## **GRADY SUBDIVISION**

APPLICATION NUMBER 4 DATE July 19, 2007

# DETAIL SITE PLAN

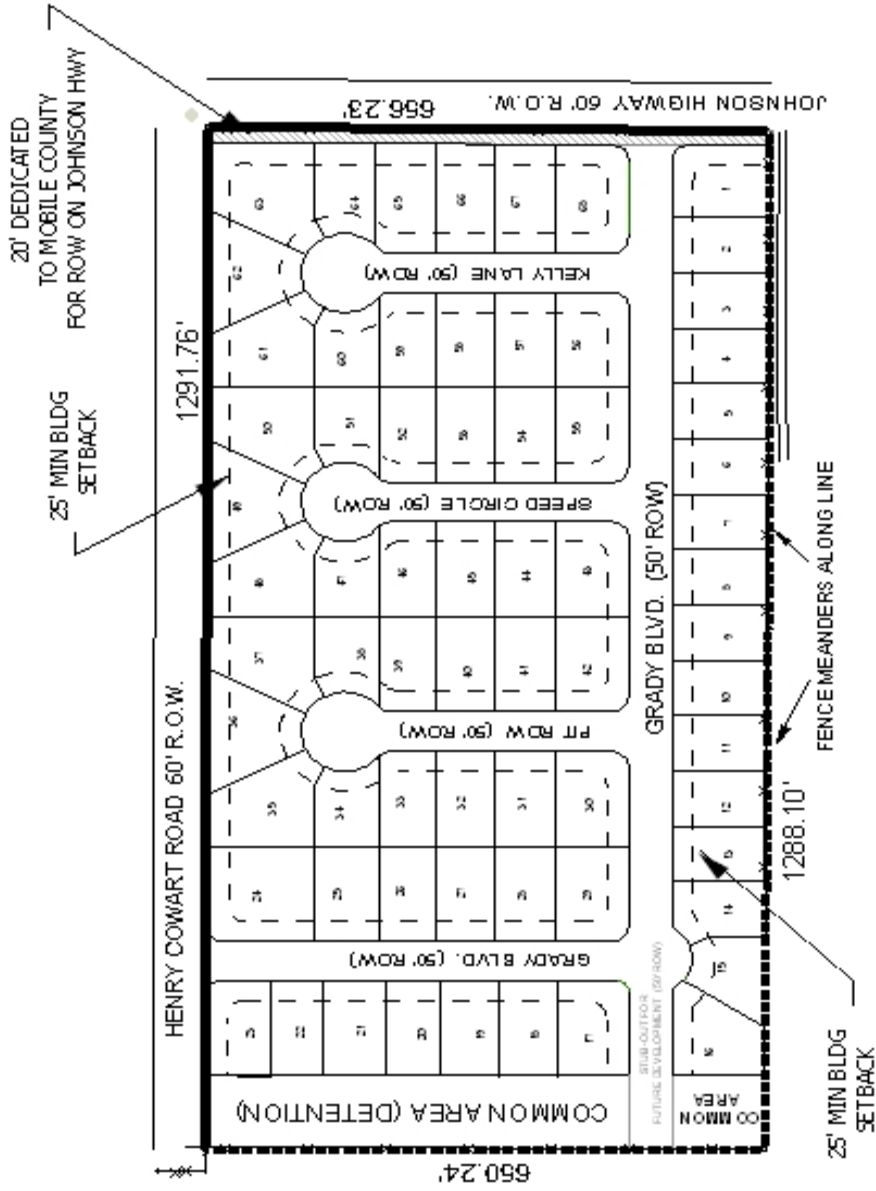
The site fronts Johnson Road West (gravel) and Cowart Road (gravel). Johnson Road West is a proposed major street with an existing 60-foot right-of-way; however, 100-foot right-of-way is required by the Major Street component of the Comprehensive Plan and it is not paved. Therefore, the dedication of sufficient right-of-way to provide 50-feet from the centerline of Johnson Road West and must be improved to county standards up to the entrance into the subdivision would be required. Cowart Road is an unpaved minor street with sufficient right-of-way of 60-feet, as illustrated on the preliminary plat. Therefore, since Cowart Road is not paved, it is recommended that access onto Cowart Road from the proposed development should not be allowed until the road is improved to County standards from Johnson Road West to the proposed entrance to the development.

The new roads for the site are to be dedicated and constructed to meet County Engineering Standards. Access management is a concern; thus the placement of a note should be required on the final plat, stating that direct access is denied to Johnson Road West for Lots 1, and 63-68; and that direct access is denied to Cowart Road for Lots 35-37, 48-50, and 61-63. Additionally, since Lots 1, 23, 24, 29, 30, 42, 43, 55, 56 and 68 are corner lots, a note should be placed on the Final Plat stating that Lots 1, 23, 24, 29, 30, 42, 43, 55, 56 and 68 are limited to one curb-cut each with the size, design and located to be determined by County Engineering.

Also, it should be noted that the plat does not provide any future street stubs to the adjacent undeveloped properties to the West, to allow for future development, as well as allowing for an additional access point to Cowart Road when the adjacent property is developed.

The requirements for street-stubs are based upon Section V.B.1. of the Subdivision Regulations, which states: "The street layout shall also provide for the future projection into unsubdivided lands adjoining of a sufficient number of streets to provide convenient circulation." The parcel West of the site is approximately 41± acres. The adjacent parcels to the West are currently undeveloped; however, the trend of this area is towards new residential subdivisions. The size of the parcels West of the site are such as to likely be the subject of future subdivision applications, hence the provision of one street-stub to the West in the vicinity of Lots 16-17 should be required.

Common areas are illustrated on the plat as detention; thus the placement of a note should be required on the final plat, designating the common area for detention, and stating that maintenance thereof shall be the responsibility of the property owners.

*A revised plat was submitted by the applicant. The revised plat depicts the connectivity to the western undeveloped parcel. It should be noted that the applicant may have the appropriate area to possibly add two lots to the development on the North and South side of the new connection creating a 70-lot subdivision.*

*The plat, as revised, is recommended for Tentative Approval, subject to the following conditions:*

- 1) the dedication of sufficient right-of-way along Johnson Road West to provide 50' from centerline for the portion on the Major Street Plan;*
- 2) that Johnson Road West be improved to County standards up to the entrance to the proposed development;*

- 3) the placement of a note on the Final Plat stating that direct access is denied to Johnson Road West for Lots 1, and 63-68; and that direct access is denied to Cowart Road for Lots 35-37, 48-50, and 61-63;*

- 4) the placement of a note on the Final Plat stating that Lots 1, 17, 23, 24, 29, 30, 42, 43, 55, 56 and 68 are corner lots be limited to one curb cut with the size, design and location to be approved by County Engineering;*
